August 17, 2015

From: Kit H. Custis
CA PG 3942, CEG 1219, CHG 254
P.O. Box 337
Fair Oaks, CA 95628

RE: Additional Comments and Recommendations on Draft Environmental Impact Report for Glenn Colusa Irrigation District's Groundwater Supplemental Supply Project, June 2015

**BUTTE COUNTY
BMO Program
Spring 2015 Alert Stage 1 or 2**

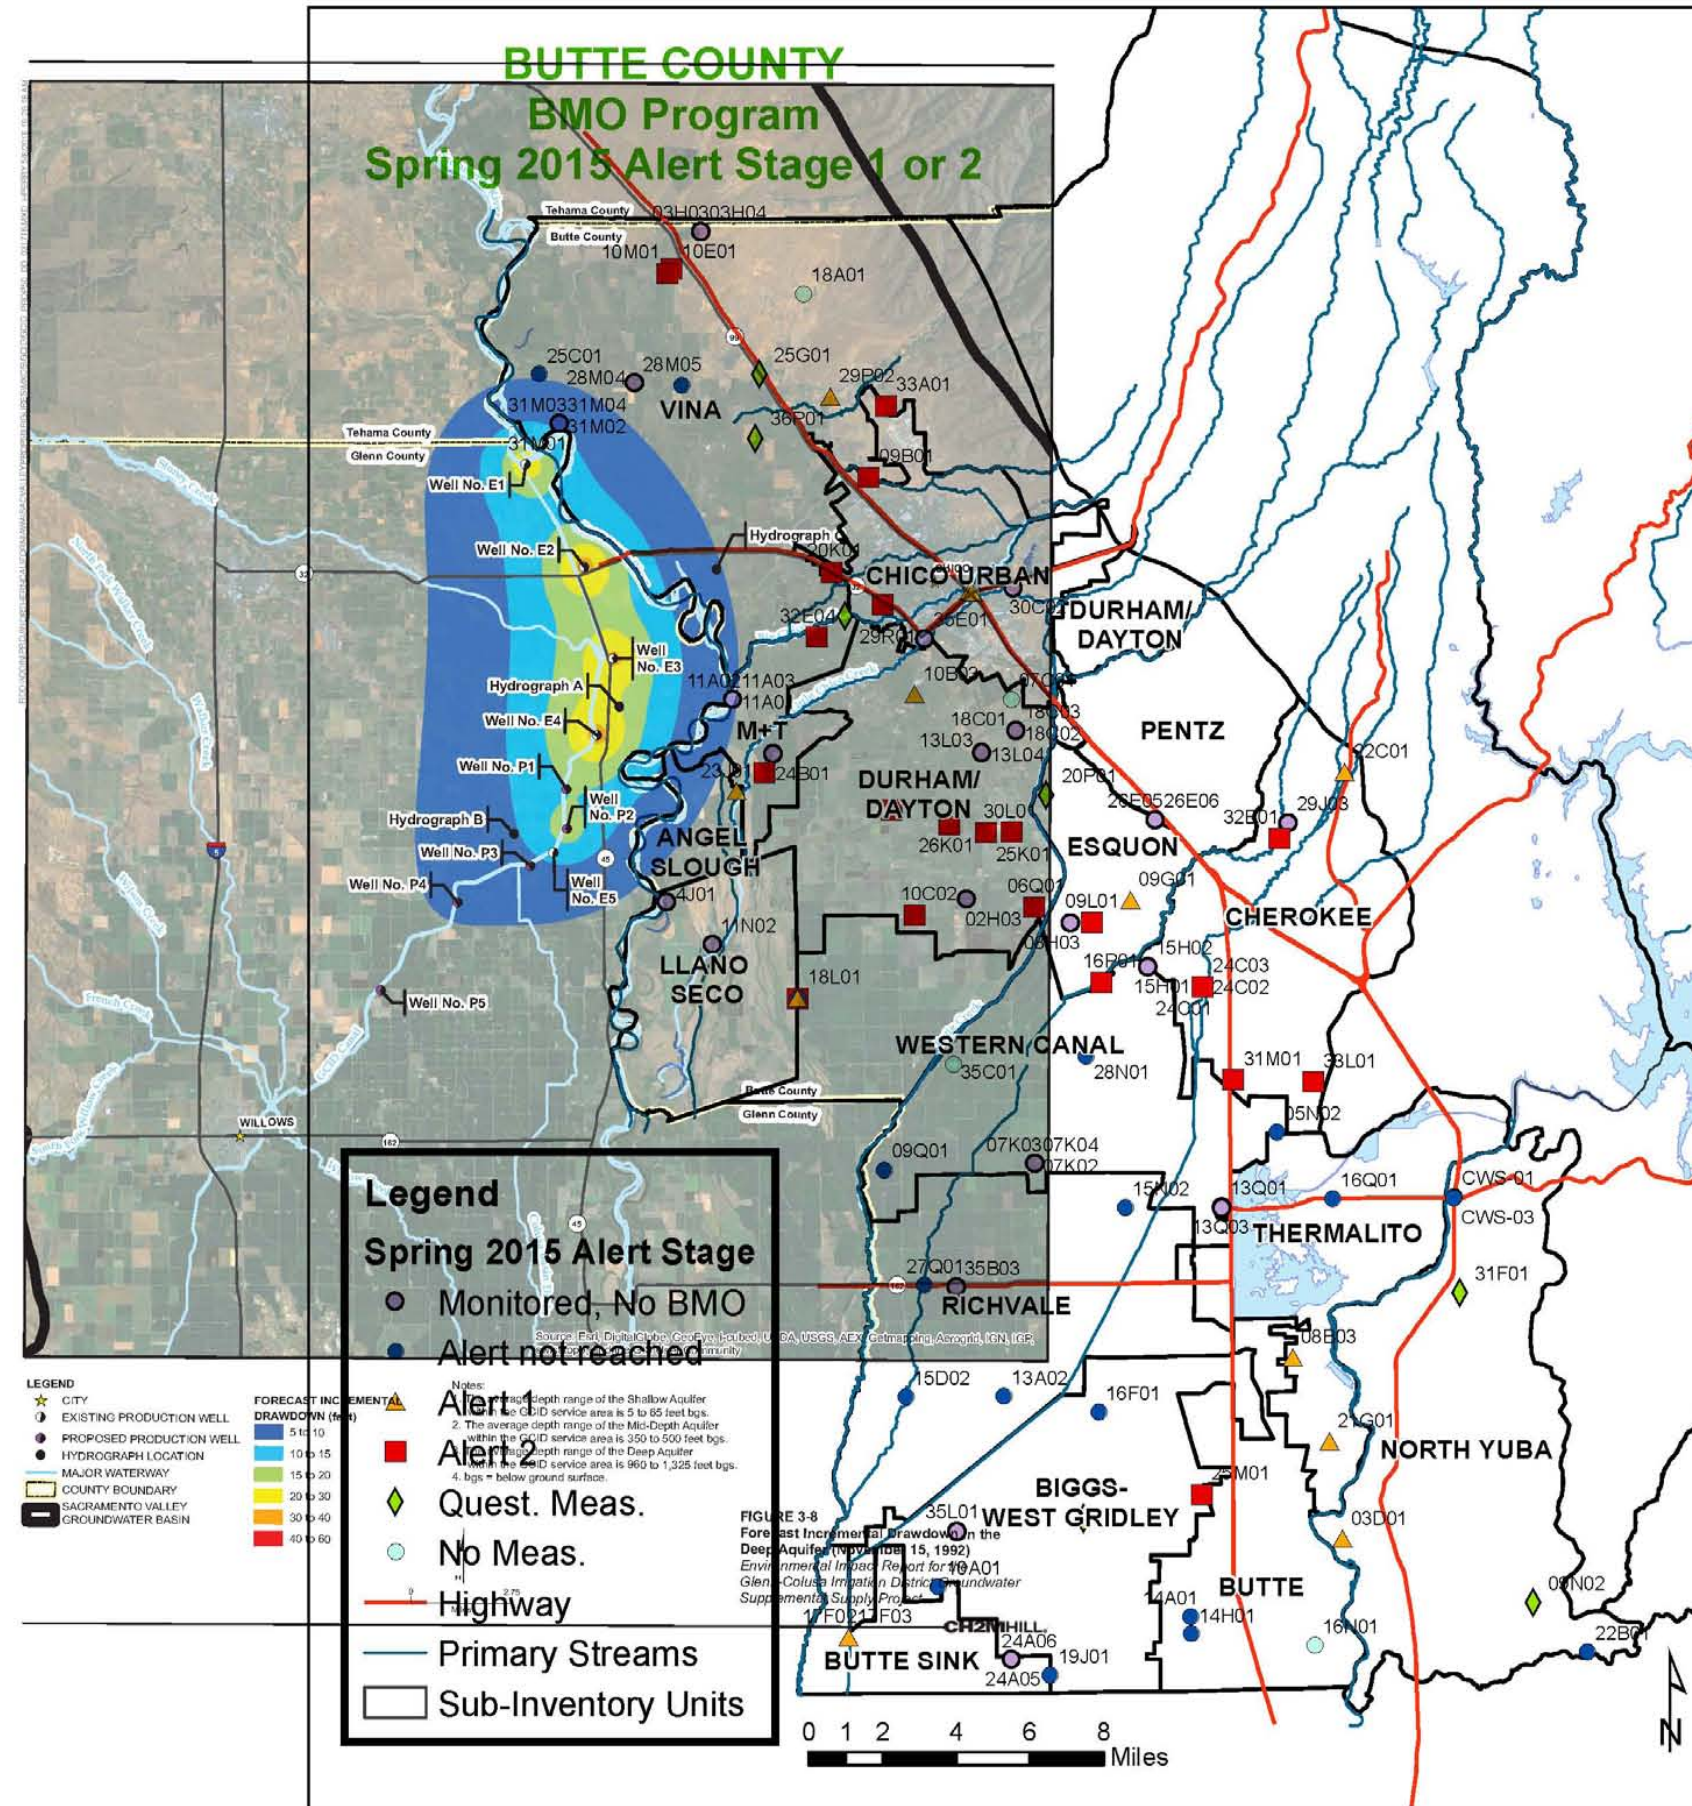
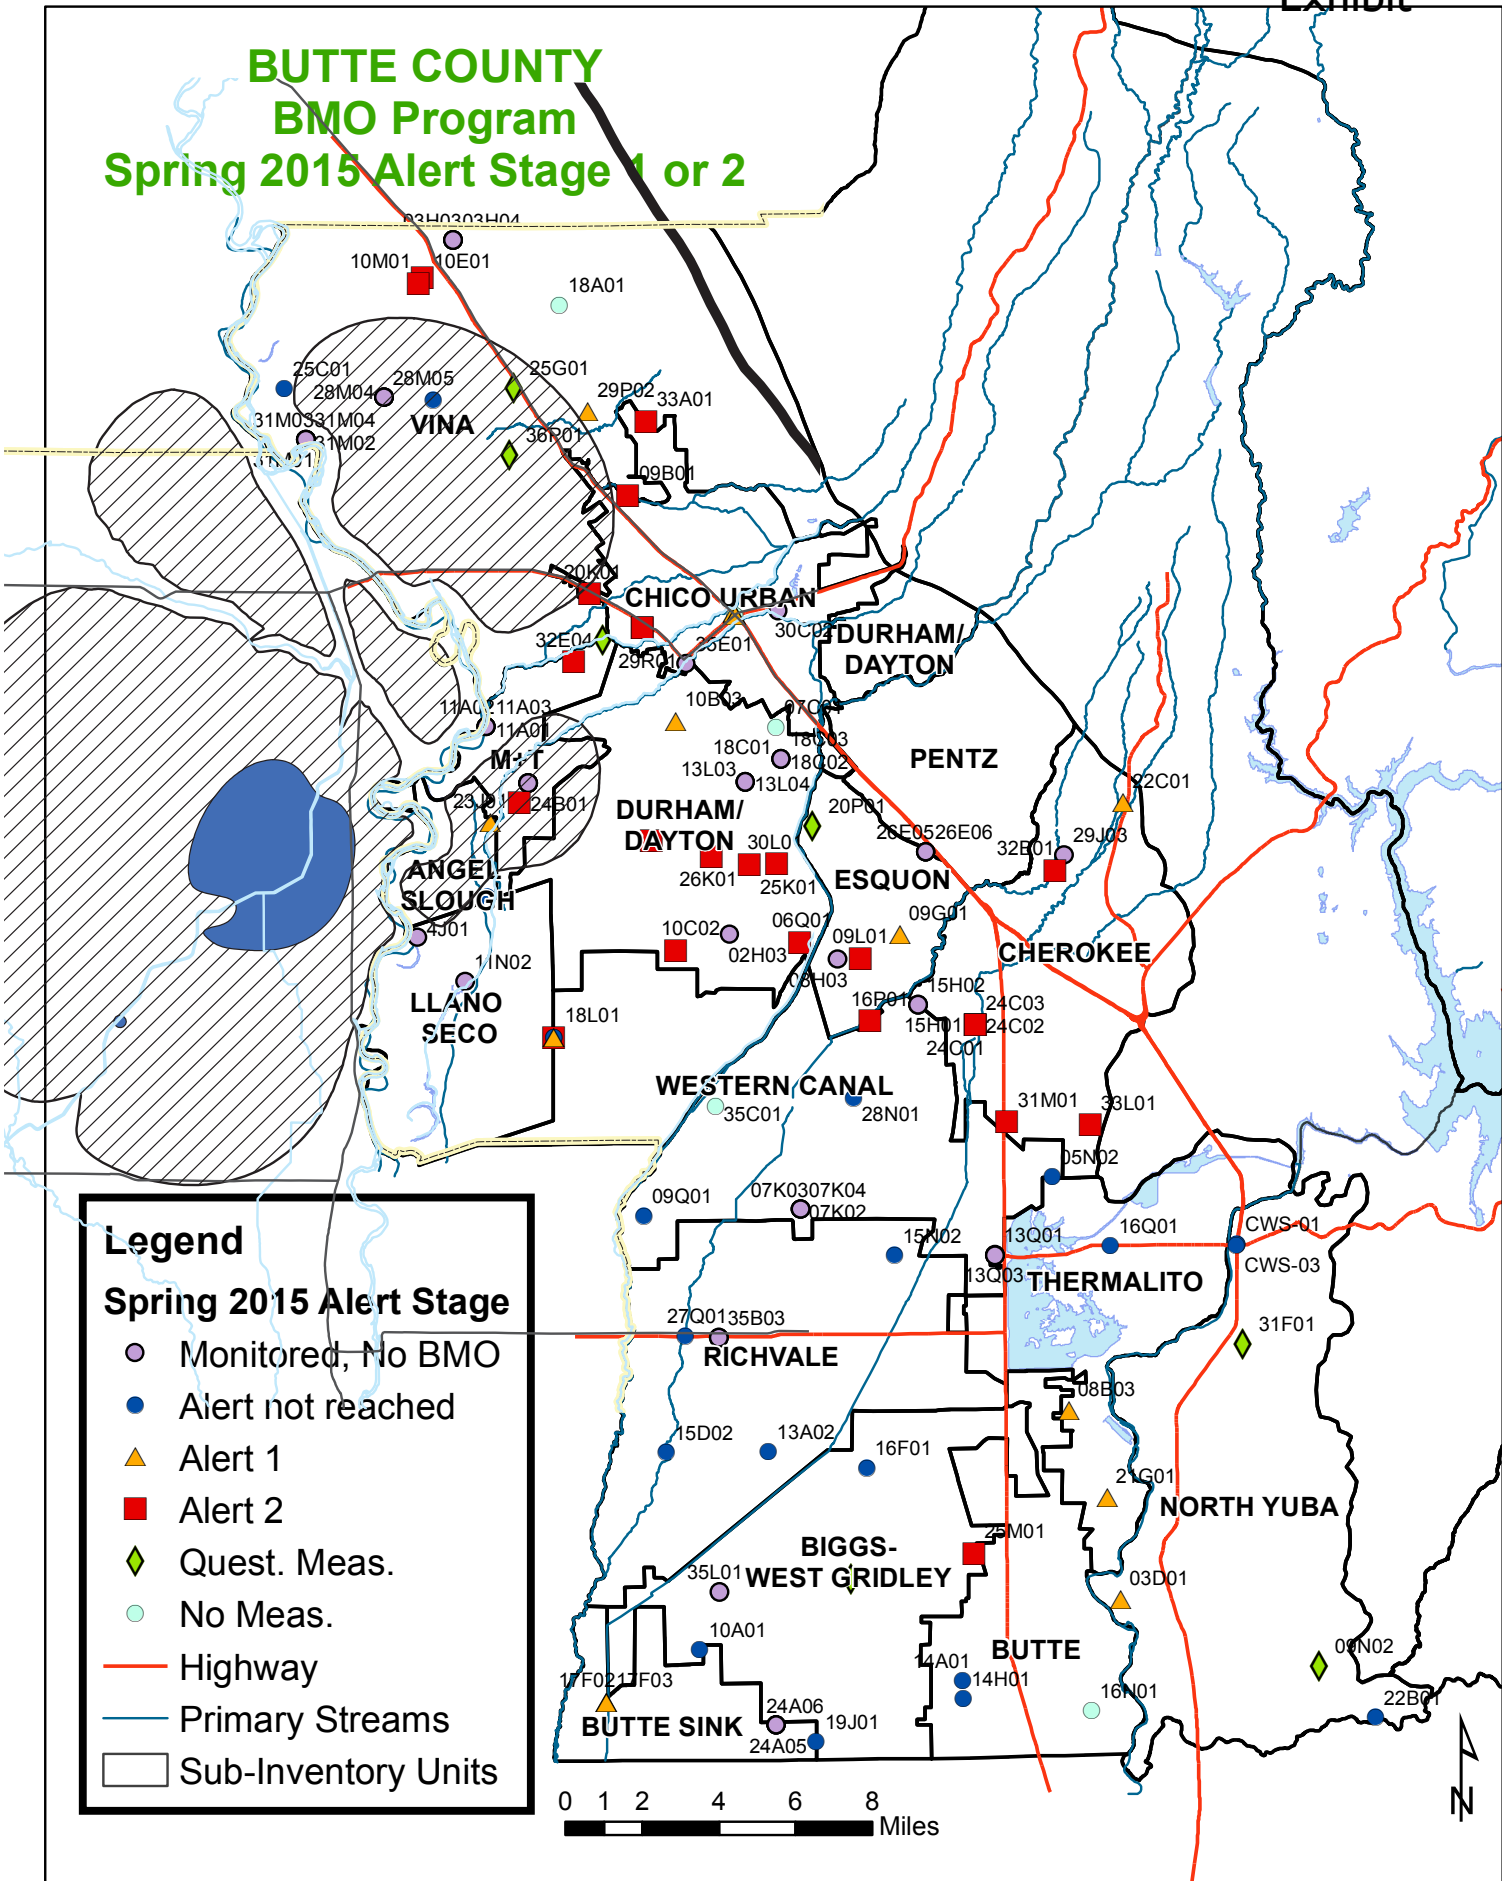
1. The DEIR stated on page 3-19 in Section 3.1.2 that there are no key wells within the simulated 5-foot-or-greater cone of depression in Butte County. This statement appears to be technically correct, but it gives an incorrect impression that there are no wells being monitored in Butte County's groundwater monitoring program that are relevant to evaluating the impacts from the GCID project. This also appears to be the justification for why the DEIR doesn't propose to utilize any of Butte County's groundwater monitoring data. There is however sufficient information to show that Butte County's groundwater monitoring program is relevant for monitoring GCID's project impacts and should therefore be incorporated into the mitigation monitoring measures WR-1 and WR-2.

Exhibit 32A is a map taken from the Butte County's BMO Program's web site that shows the spring 2015 Alert Stages 1 and 2 for wells in the county (<http://www.buttecounty.net/waterresourceconservation/GroundwaterLevels.aspx>). Exhibit 32B is a composite map made of the Butte County Spring 2015 BMO map and DEIR Figure 3-8, which shows the drawdown in the deep aquifer for the November 15, 1992 simulation. Exhibit 32B shows that there are several wells adjacent to the 5-foot-plus drawdown that are in Alert Stage 1 or 2. Exhibit 32C is a composite map made of the Butte County Spring 2015 BMO map and DEIR Figure 3-6, which show the outermost drawdown area for the November 15, 1992 simulation. Exhibit 32C shows that there are a number of wells being monitored by Butte County that lie within the outermost impact area for the GCID project. Several of these wells are in Alert Stage 1 or 2. More information about the Butte County groundwater level monitoring program and BMOs can be found at web site <http://www.buttecounty.net/waterresourceconservation/BasinManagementObjectives.aspx> and Butte Count groundwater quality monitoring information at <http://www.buttecounty.net/waterresourceconservation/GroundwaterQuality.aspx>.

I recommend that the DEIR be amended to incorporate the Butte County groundwater level and quality monitoring program data into mitigation measures WR-1 and WR-2. In addition, groundwater level data from Butte and Tehama county wells should be evaluated for long-term antecedent trends as required for Glenn and Tehama county wells in mitigation measure WR-1.

TEHAMA COUNTY GROUNDWATER MONITORING WELLS

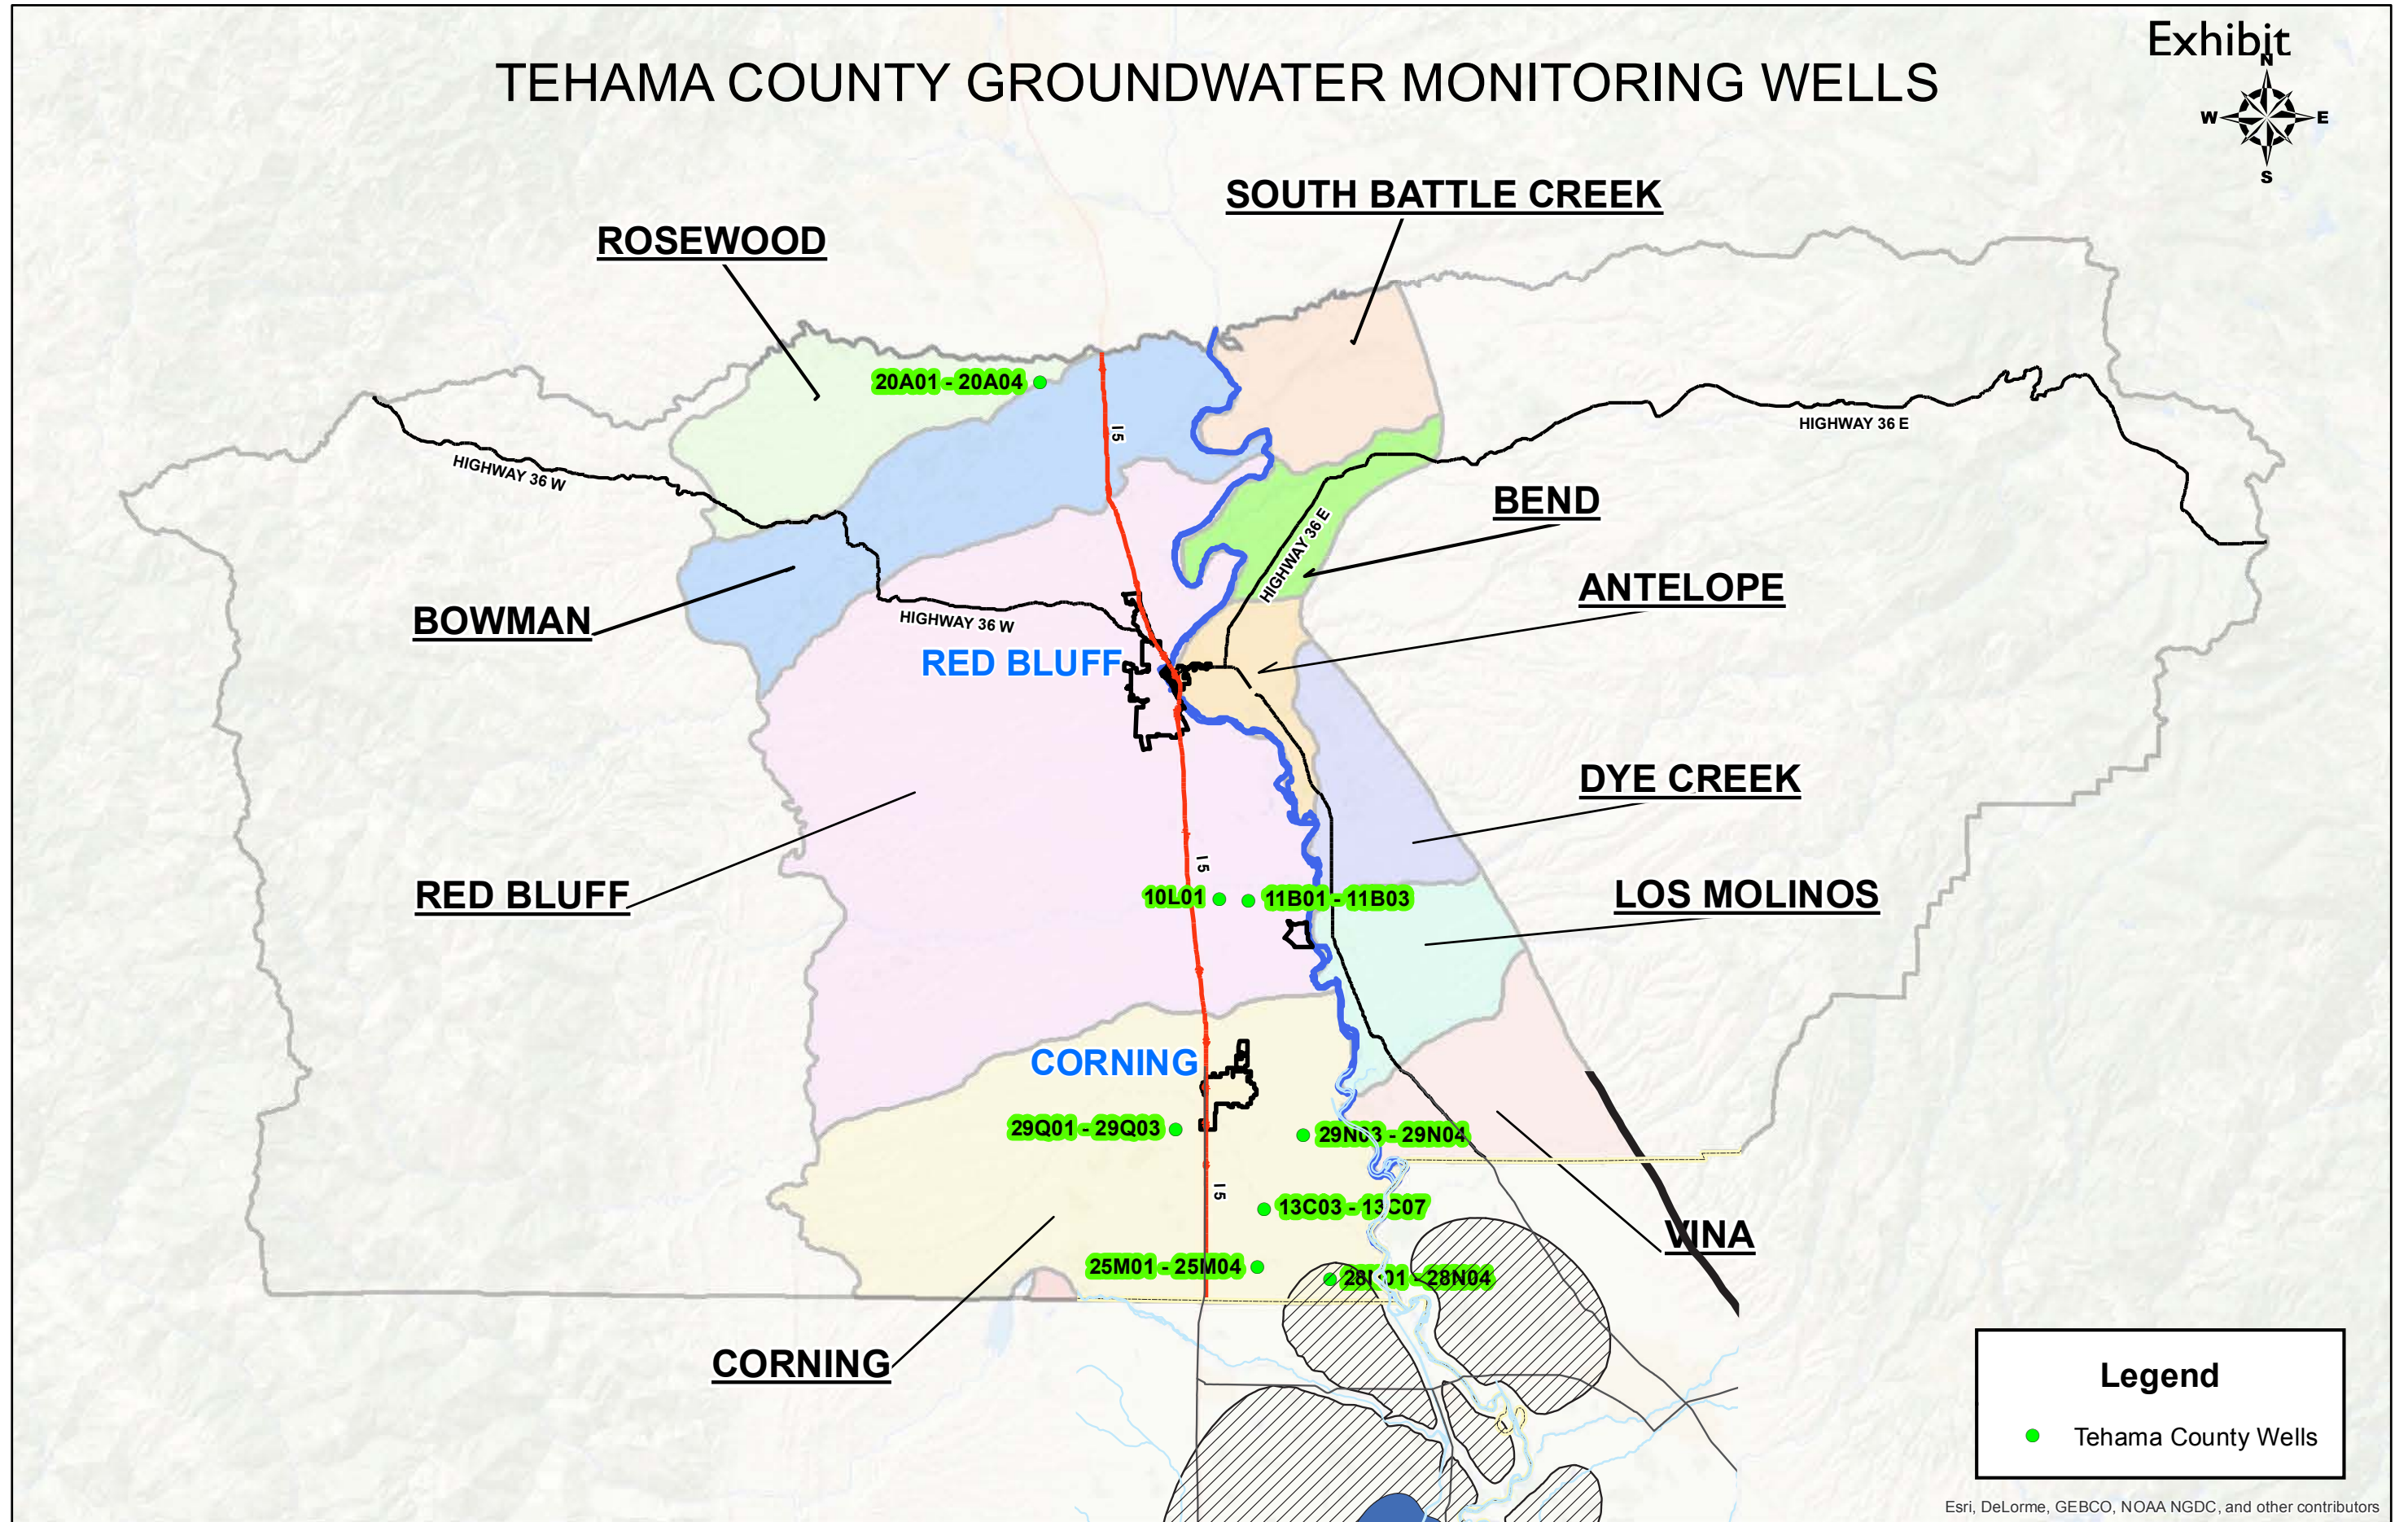
Exhibit 32D is a map taken from Tehama County's AB-3030 Groundwater Management Plan that shows the key monitoring wells overlain by the GCID project's outermost drawdown

area. There are several multilevel wells in southern Tehama County that are within or adjacent to the GCID project's impact area. These wells should be included in the GCID groundwater-monitoring program. Information on the characteristics of the aquifer in Tehama County, the key wells, hydrographs for key wells and groundwater trigger levels can be found at web sites: <http://www.tehamacountypublicworks.ca.gov/Flood/wells.html>, and <http://www.tehamacountypublicworks.ca.gov/Flood/groundwater.html>.
